Access Compliance Report

Public Rights-of-Way

(Curb Ramps)

Intersection ID: 28846	Main Street: BRENLY_CT	Cross Street: FAIRCHASE_AV	Location:	S
ADA ID: 94B5172AD90D	Ramp Type: BlendTrans1	Initial Pass/Fail: Fail	Overall Compliance: No	Severity Score: 10

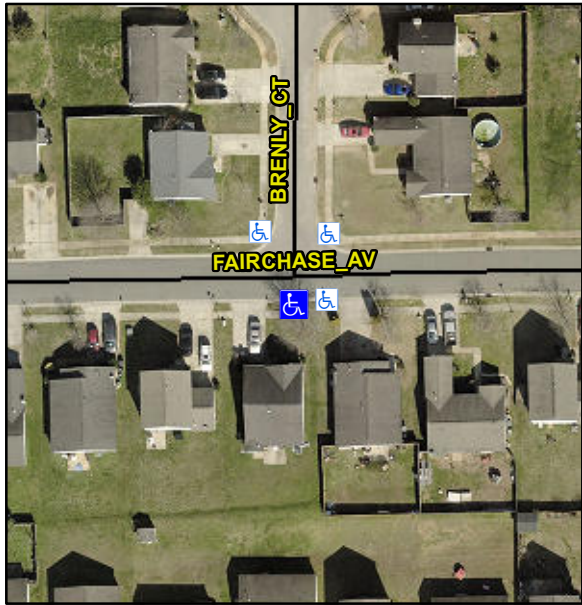
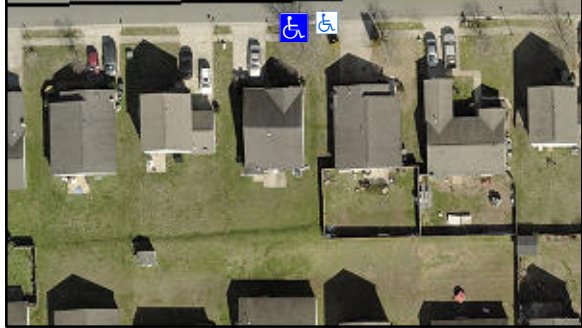
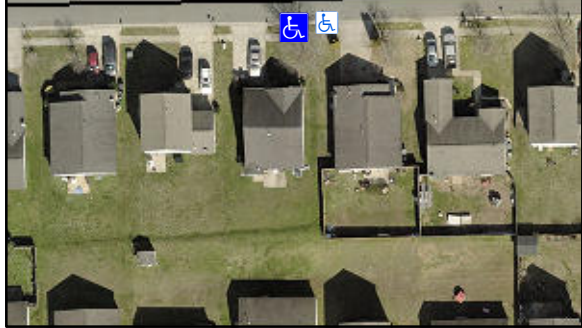
Codes/Mitigation Info/Possible Solution			Field Measurements/Component Compliance					
	Possible Solutions:		Compliance	Description	Data	Compliance	Description	Data
	Remove & Replace Curb Ramp With Two New Directional Ramps or Equivalent.		N/A	Ramp Length (in)	48.0	Yes	BlendTrans Slope (%)	4.9
			No	Ramp Width (in)	44.0	No	BlendTrans XSlope (%)	3.1
			N/A	Flare Type LT	N/A	N/A	Flare Type RT	N/A
			N/A	Flare Slope LT (%)	N/A	N/A	Flare Slope RT (%)	N/A
			N/A	Flare Traversable LT?	N/A	N/A	Flare Traversable RT?	N/A
			N/A	Landing Length (in)	N/A	N/A	DWS Provided?	N/A
			N/A	Landing Width (in)	N/A	N/A	DWS Contrast?	N/A
			N/A	Landing Slope (%)	N/A	N/A	DWS Length (in)	N/A
			N/A	Landing X Slope (%)	N/A	N/A	DWS Full Width?	N/A
	Surveyor Notes:		N/A	Landing Curb? (Y/N)	N/A	N/A	DWS Offset (in)	N/A
	N/A		N/A	Shared Landing?	N/A			
	PROW/ADA:		N/A	Gutter Ponding?	N/A	N/A	Gutter Slope (%)	N/A
	Not Found, R304.5.1, R304.5.3		N/A	Gutter Lip Ht (in)	N/A	N/A	Gutter X Slope (%)	N/A

N/A	Painted X Walk1?	No	N/A	Painted X Walk2?	N/A
				X Walk 1 Direction	To N		X Walk 2 Direction	N/A
				X Walk 1 Width (in)	N/A		X Walk 2 Width (in)	N/A
				X Walk 1 Slope (%)	4.6		X Walk 2 Slope (%)	N/A
				X Walk 1 X Slope (%)	1.9		X Walk 2 X Slope (%)	N/A
			N/A	Ramp inside XWalk1?	N/A	N/A	Ramp inside XWalk2?	N/A
				Road Slope (%)	1.9		Clear Space?	N/A
				Road X Slope (%)	4.6	N/A	Clear Space to XWalk (in)	N/A
			N/A	Any Obstructions?	N/A	N/A	Storm Grate/Utility Hazard?	N/A
				Obstruction Type			Storm Grate/Utility Type	
					N/A			N/A
						Yes	Surface Condition? (G/P)	Good
						No	Curb Slope (%)	12.4
